Florida Department of  
Environmental Protection  
Inspection Checklist

**Facility Name:** J.E.D LANDFILL (F/K/A OAK HAMMOCK DISPOSAL)

**On-Site Inspection Start Date:** 05/22/2015

Erosion and exposed waste Cell 8

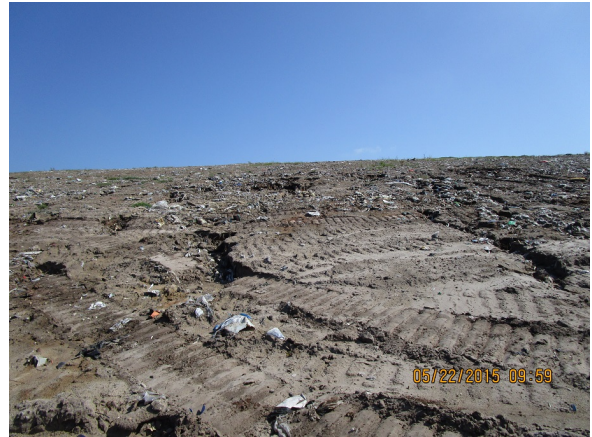
Explanation: Erosion and exposed waste was noted on the south slope of Cell 8.

A large area on the south slope of Cell 8 was eroded and waste was exposed. The facility should be repairing areas of erosion as they appear so that large areas do not become eroded and waste does not become exposed. After discussion with John Hartings and Bob Walls, it was agreed that the facility would send pictures of the eroded area covered and repaired by July 1st.

Corrective Action: The facility shall complete repairs to the slope by June 30, 2015 and submit pictures to the Department of the repaired area by July 1, 2015.

On June 29, 2015, the facility submitted documentation to the Department showing the completed corrective actions.

On June 29th, the Department received pictures of the south slope of Cell 8 covered and repaired.
